FAQ Number 18-0017 FAQ Revision 0ba1
FAQ Title Conditional Trip Probability for Modeling Operator Discretion

Plant: Harris Date: June 27, 2018
Contact: Harold Stiles Phone: (919) 546-4570
Email: Harold.Stiles@Duke-Energy.com

Figure 1: CTP Process Related to NUREG/CR-6850

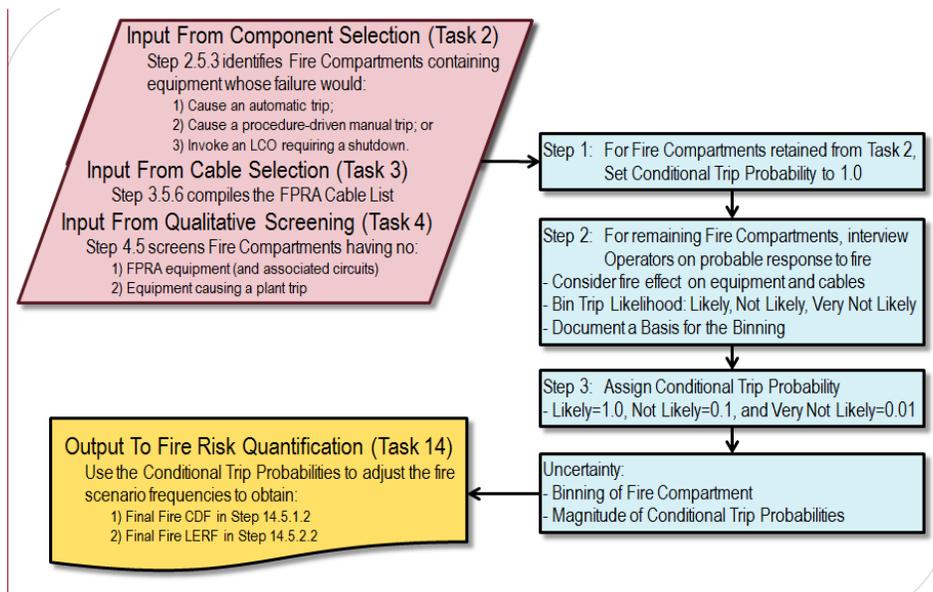
Commented [HJ15]: Staff comments in this FAQ apply to Figure 1 as well.
